N3381A-01B**S E R V I C E****N O T E**Supersedes:
N3381A-01A**N3381A PNA Series RF Network Analyzers**

Serial Numbers: 00000000 thru 46999999

July 26, 2007

Figure 1

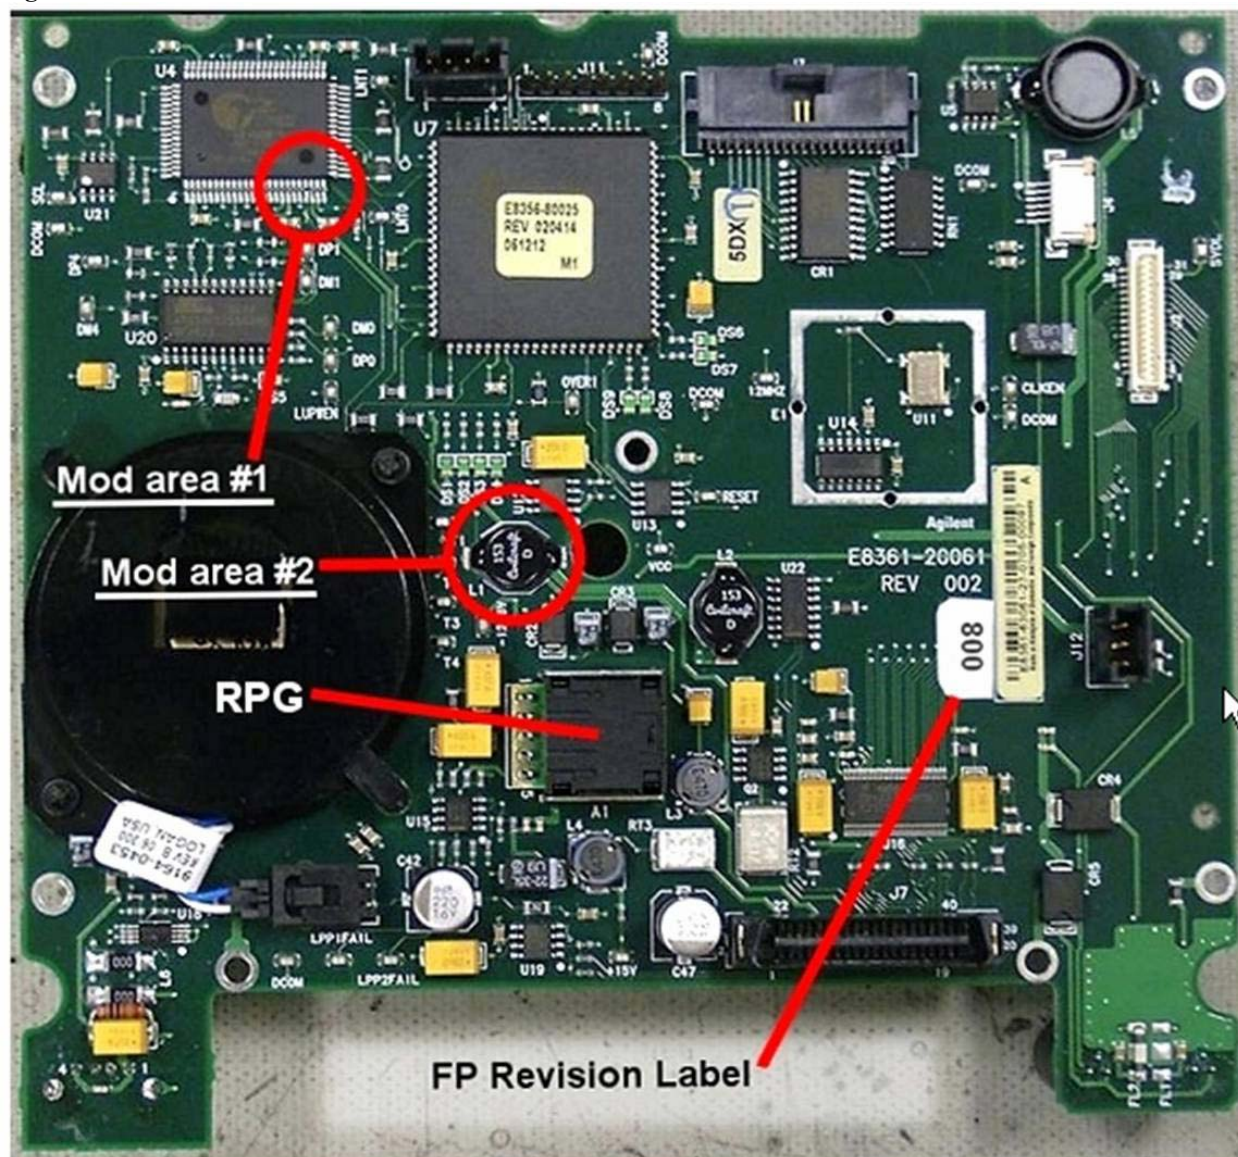
Refer to Figure 1 for the two modification areas to be addressed. Note that while this picture happens to show the FPI board completely removed from the front frame assembly, this is not necessary to perform the required modifications.

- Modification #1 consists of shorting two pins of U4 together with a small amount of solder.
- Modification #2 consist of removing L1.

Unsolder and completely remove the black surface mount inductor L1 from the front panel assembly board. This is no longer needed and can be discarded.

Figure 2

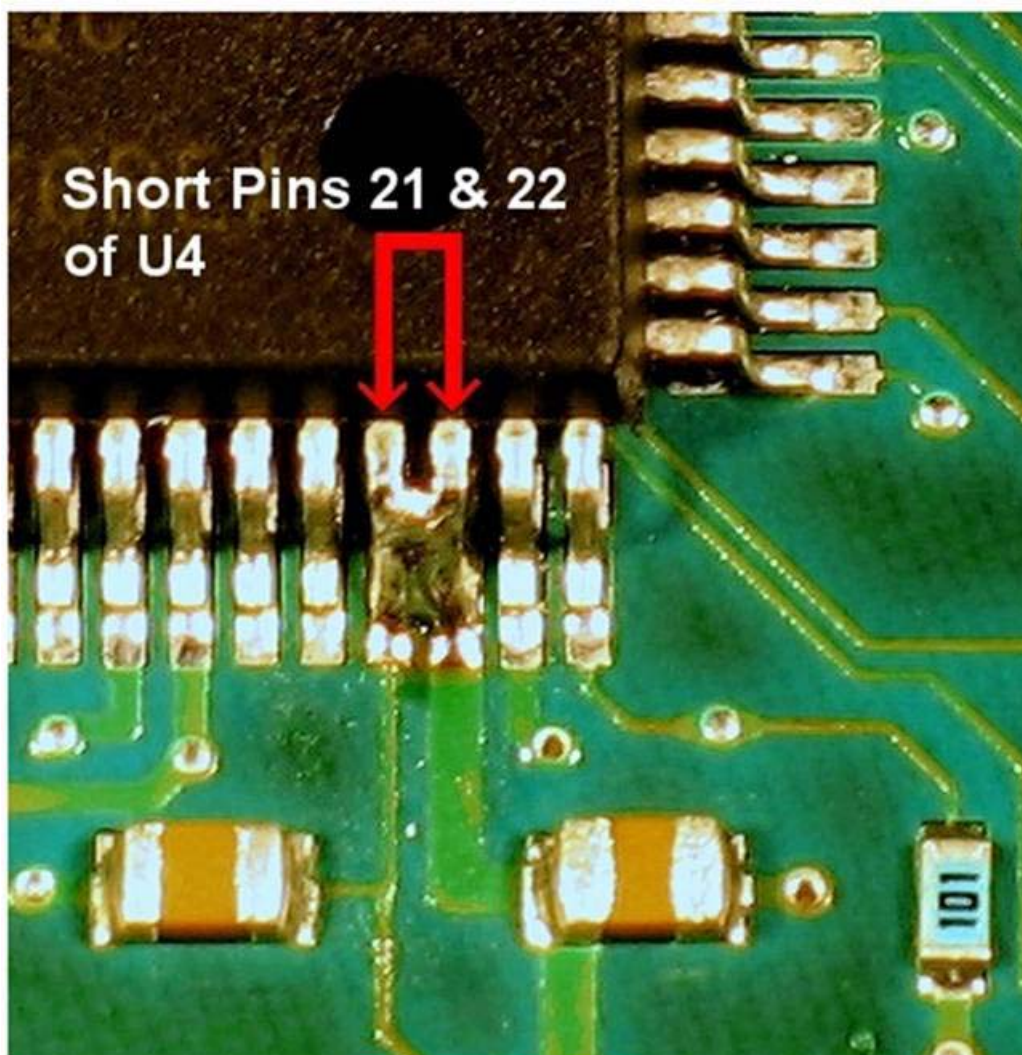
Carefully solder pins 21 and 22 together on U4. Refer to Figure 2 for the exact location. Use care so that no other pins are shorted. Use of a very fine tip soldering iron is recommended and a large work-task magnifying glass is very helpful.
